1001330 & 1001503 Guardian Touch Screen Replacement for PT2287 Guardian Touch Screen

Description

The Guardian PT2287 Touch Screen has been discontinued by the vendor.

Technician Requirements

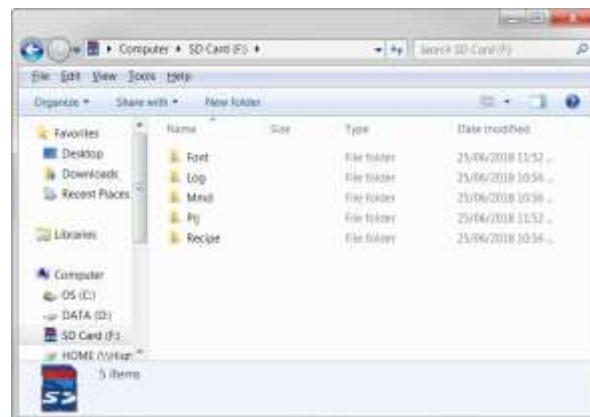
- Different mounting system
- Change to the location of ports available to use
- Newer programming software version required
- All new touch screen program to comply with updated versioning
- Program can now be stored on a SD card

Please note that the new SD Card file structure can be used with the new touchscreen (1001330) only. All PT2287 touch screens must use this version of software: *Templates/CMore/PT2287 – EA7 touch screen/H3 Programming template*

1. Update touch screen programming software, available here:
Guardian Touch Screen Software/C More Programming Software – EA9
2. Download updated touch screen program template, available here:
Templates/CMore/1001330 – EA9 touch screen/Touch screen programming template
3. Download SD card file structure, available here:
Templates/CMore/1001330 – EA9 touch screen/SD Card file structure
